### ■カタログ誤記訂正箇所一覧

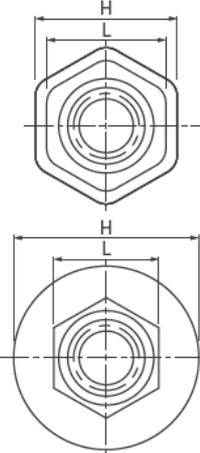
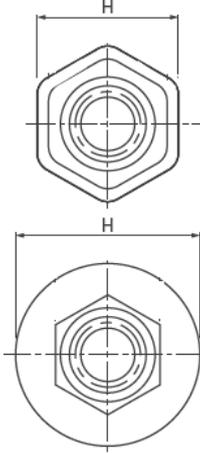
掲載項	訂正箇所	誤(訂正前)	正(訂正後)
P31	頭形状マーク	平皿頭 	皿頭 
	製品図面(ナット径(D)の範囲) ※左側の皿頭の図		ナット径(D)の範囲を修正 
	製品図面(全長(L)・ナット径(D)の範囲) ※右側の平頭の図	全長(L)は頭高(P)を含む 	・全長(L)は頭高(P)を含まない ・ナット径(D)の範囲を修正 
	全長 L	KS-325-RLT	9.3
			9.5
